April 12, 2019

Below please find responses to questions from your March 25th planning board meeting regarding site plan review for the North Campus Residential Expansion project. As you already know, work within the Village includes landscaping, pavements and temporary contractor operations.

RAISED CROSSWALK

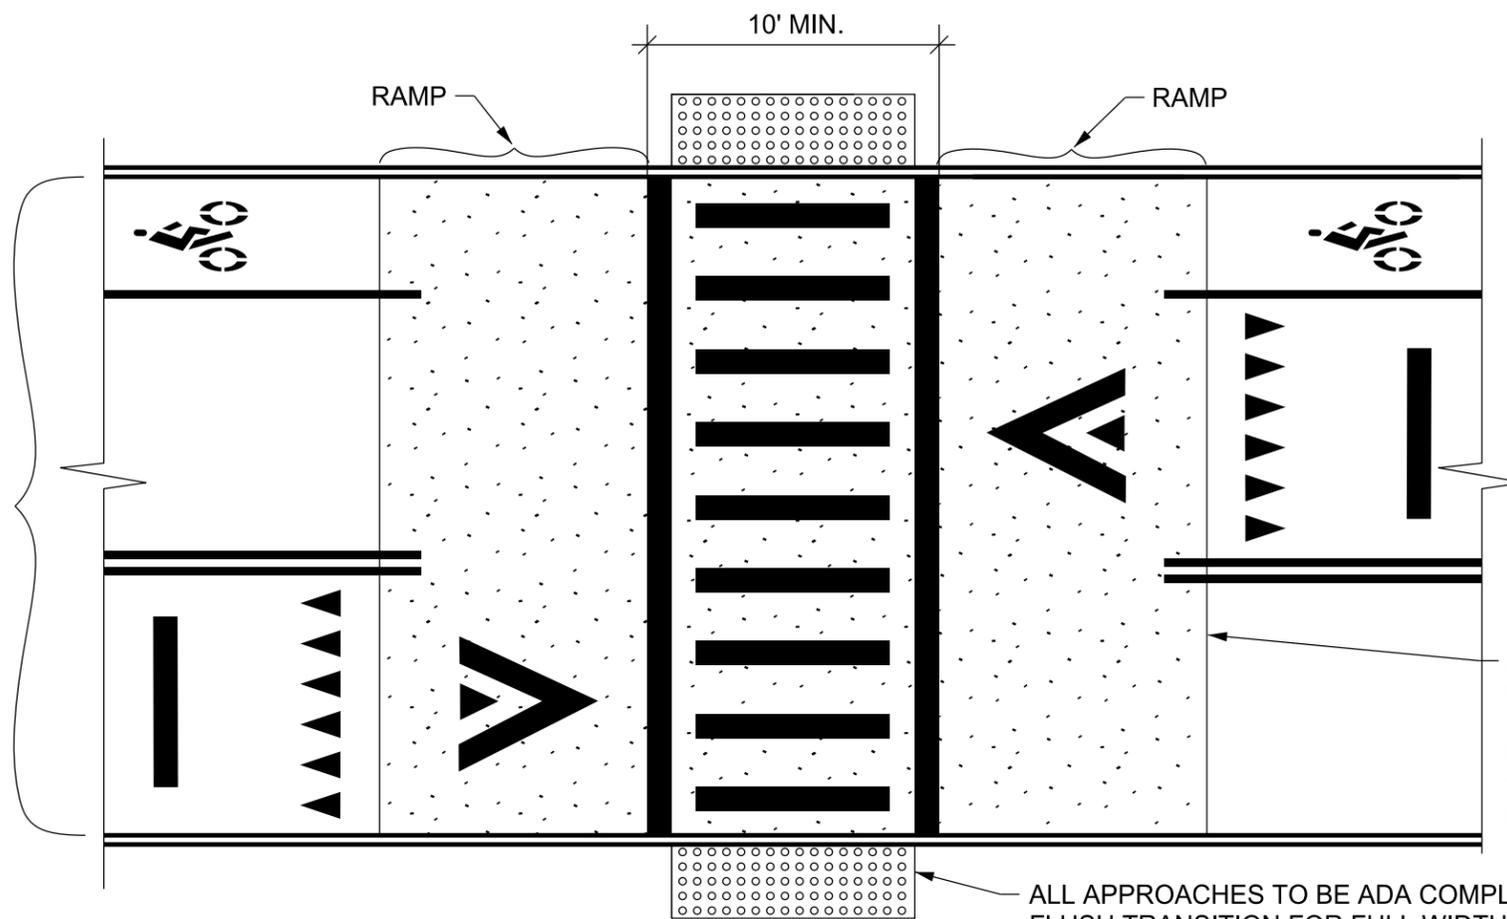
3. Will the pedestrian crossings on Jessup be high visibility?

The project includes improving two pedestrian crossings on Jessup Road between the Robert Purcell Community Center (RPCC) and the Townhouses. Raised crossings are proposed at the Northcross, Jessup Road intersection and from the Townhouses to the RPCC. In addition to being raised crossings, the crossings will include pedestrian crossing signage, piano/ladder striping on the path of travel and chevron markings for approaching motorists as per Cornell design standards. A copy of the Cornell typical detail for raised crosswalks is attached.
